HISTORIC AND DESIGN REVIEW COMMISSION

HDRC CASE NO: 2019-046
ADDRESS: 605 NOLAN
LEGAL DESCRIPTION: NCB 547 BLK 19 LOT W 48 FT OF 12
ZONING: R-6, CD, H
CITY COUNCIL DIST.: 2
DISTRICT: Dignowity Hill Historic District
APPLICANT: Nicolas Rivard
OWNER: Nicolas Rivard
TYPE OF WORK: Construction of a 2-story, rear accessory structure
APPLICATION RECEIVED: January 25, 2019
60-DAY REVIEW: March 26, 2019
REQUEST:

The applicant is requesting conceptual approval to construct a rear accessory structure on the lot at 605 Nolan, located within the Dignowity Hill Historic District. Modifications to the site will also include the installation of a rear yard parking area.

① Site Plan
1/8" = 1'-0"

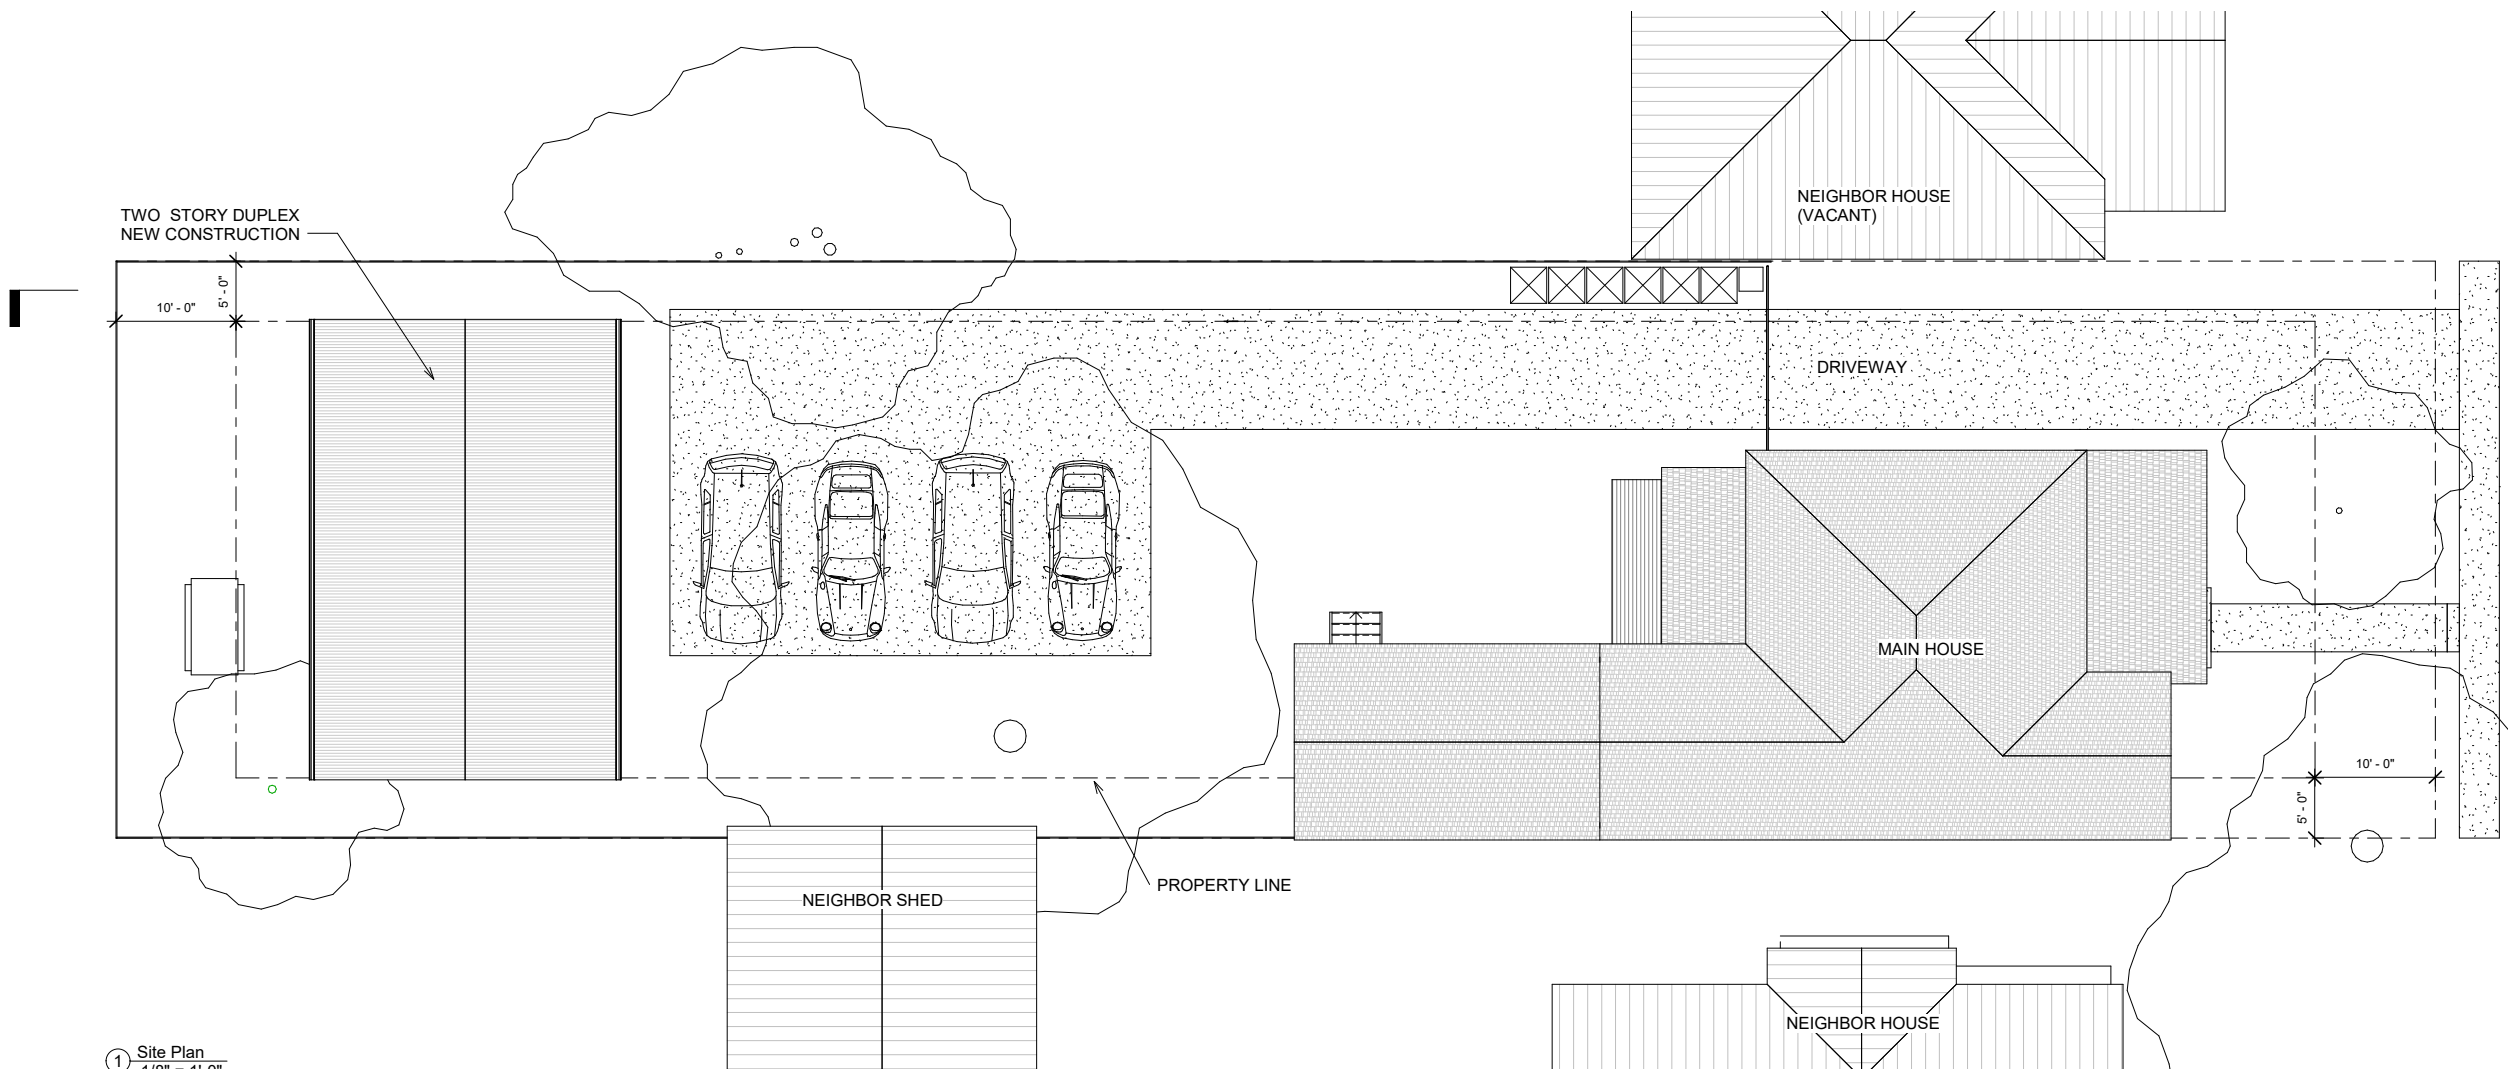
- c. **SETBACKS & ORIENTATION** – The Guidelines for New Construction 5.B. state that the predominant garage orientation found along the block should be matched. Additionally, historic setback patterns of similar structures should be followed. The applicant has proposed to locate the accessory structure at the rear of the property, where accessory structures are historically located. Additionally, the applicant has proposed a rear setback to be consistent with the rear setbacks of other, rear accessory structures found on this block. Staff finds the applicant's proposed setbacks and orientation appropriate.

- h. **SITE WORK** – The applicant has proposed automobile parking at the rear of the site, between the primary historic structure and the proposed rear accessory structure. Staff finds the proposed parking location to be appropriate; however, staff finds that pervious paving should be used.

Building Elevations

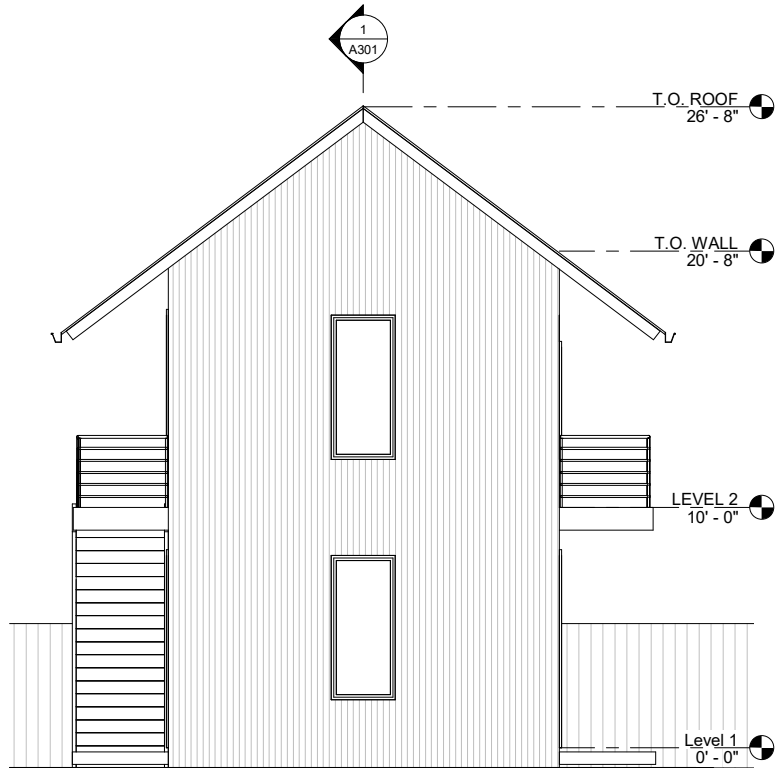
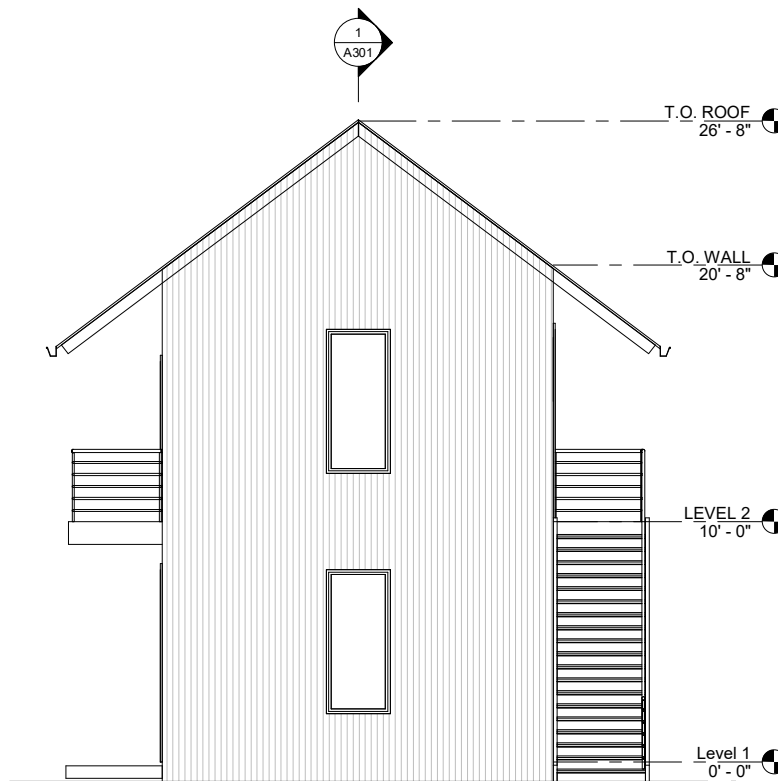
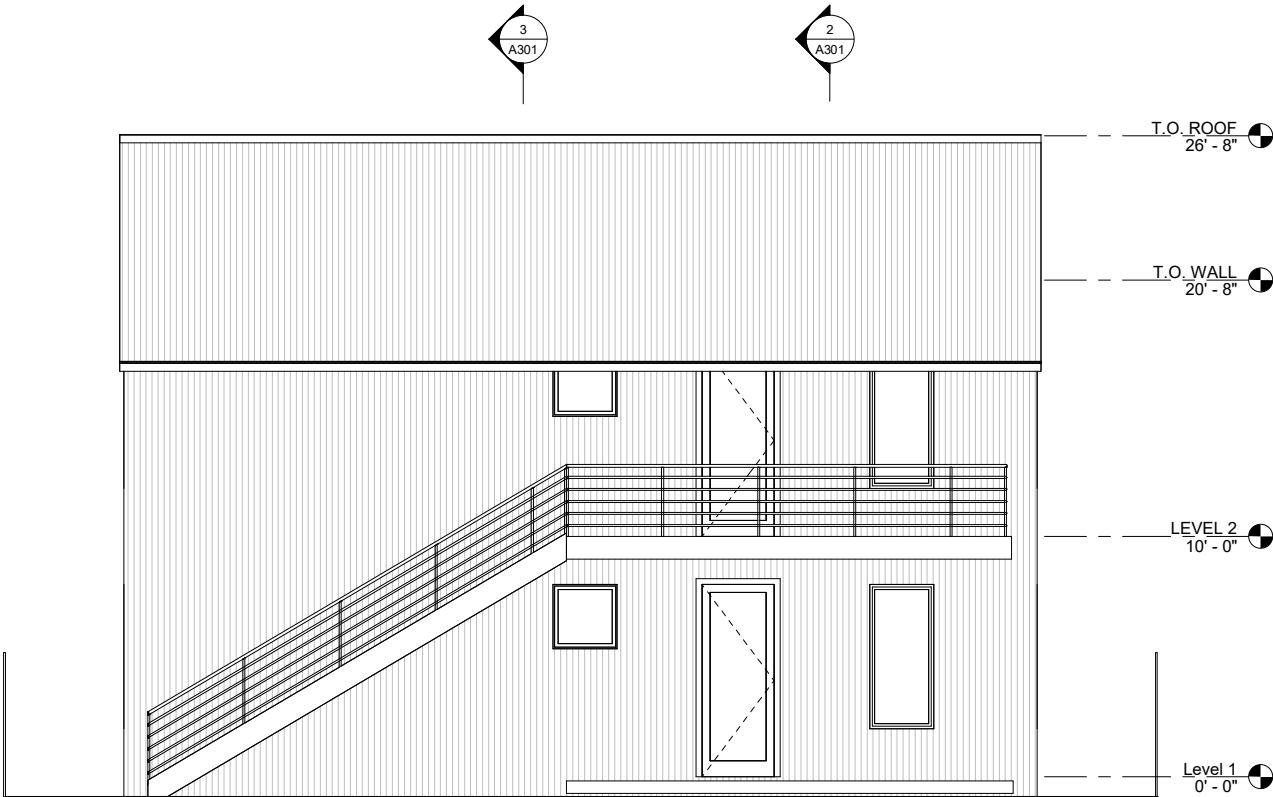
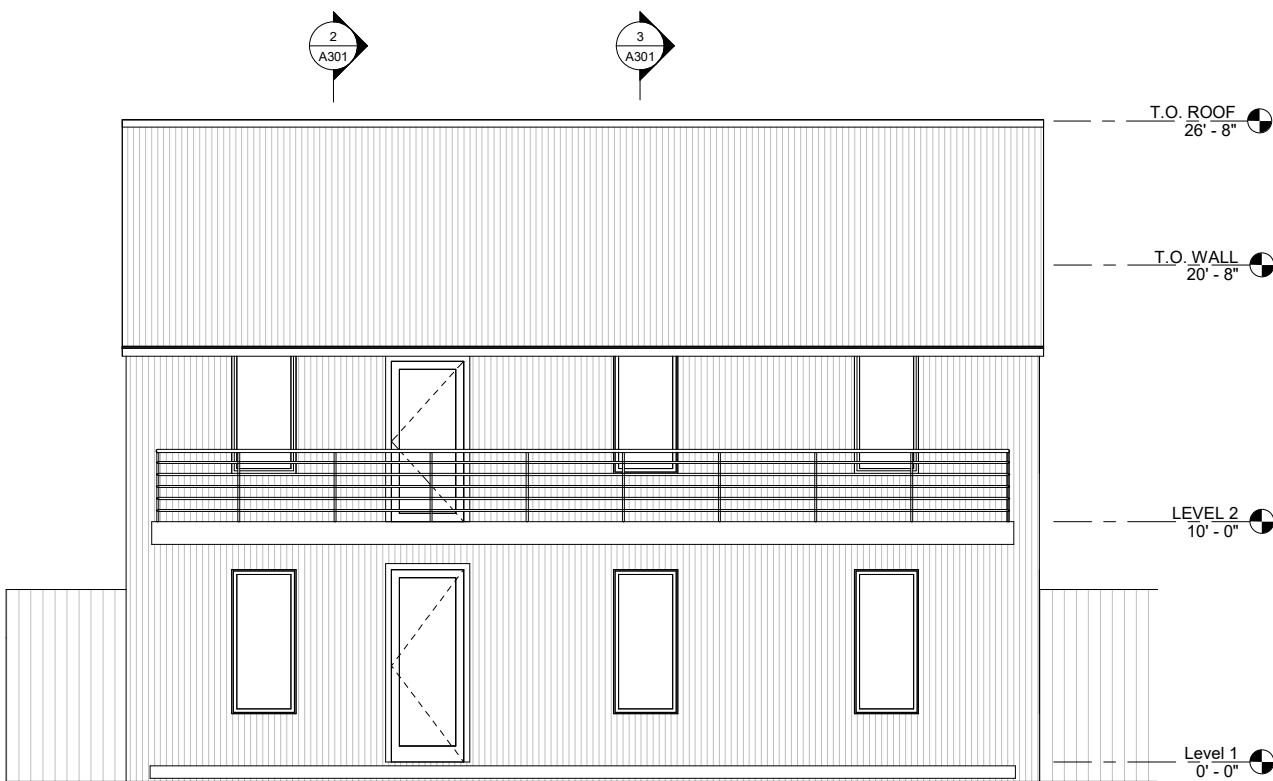
- d. **MASSING** – The Guidelines for New Construction 5.A.i. notes that new garages and outbuildings should be visually subordinate to the principal historic structure in terms of their height, massing and form. The applicant has noted an overall proposed height of 26' – 8". The height of the primary historic structure on the lot is 27' – 6". The applicant has sited the proposed new construction toward the rear of the site. Given the subordinate height and distance from the right of way at Nolan, staff finds the proposed massing to be appropriate.

- f. **CHARACTER** – The Guidelines for New Construction 5.A.iii. notes that new garages and outbuildings should relate to the period of construction of the primary historic structure on the lot through the use of complementary materials and simplified architectural details. The applicant has proposed materials that include corrugated metal siding, corrugated metal roofing, aluminum windows, composite decking and metal mesh guardrails. The proposed materials are not consistent with those found on the primary historic structure and are not consistent with the Guidelines. Staff finds that an asphalt shingle roof or a standing seam metal roof that feature panels that are 18 to 21 inches wide, seams that are 1 to 2 inches in height, a crimped ridge seam or a low profile ridge cap and a standard galvalume finish. If a ridge cap is preferred, the profile is to be submitted to staff for review and approval. Siding and guardrails that feature metal materials are not found historically within the district.

- g. **WINDOW MATERIALS** – As noted in finding f, the applicant has proposed aluminum windows. Staff finds that a double-hung, one-over-one wood windows or aluminum-clad wood windows be used.. Meeting rails must be no taller than 1.25" and stiles no wider than 2.25". White manufacturer's color is not allowed, and color selection must be presented to staff. There should be a minimum of two inches in depth between the front face of the window trim and the front face of the top window sash. This must be accomplished by recessing the window sufficiently within the opening or with the installation of additional window trim to add thickness. Window trim must feature traditional dimensions and architecturally appropriate sill detail. Window track components must be painted to match the window trim or concealed by a wood window screen set within the opening.

- i. That either wood siding or composite siding featuring a smooth finish and an exposure of four inches be used based on finding f.
- ii. That either an asphalt shingle or a standing seam metal roof be used as noted in finding f. The proposed standing seam metal roof should feature panels that are 18 to 21 inches in width, seams that are 1 to 2 inches in height, a crimped ridge seam or a low profile ridge cap. The low profile ridge cap should be submitted to staff for review and approval.

- iii. That wood railings be installed in place of the proposed metal mesh railing as noted in finding f.
- iv. That wood or aluminum clad wood windows be installed. The proposed windows should feature meeting rails that are no taller than 1.25" and stiles no wider than 2.25". White manufacturer's color is not allowed, and color selection must be presented to staff. There should be a minimum of two inches in depth between the front face of the window trim and the front face of the top window sash. This must be accomplished by recessing the window
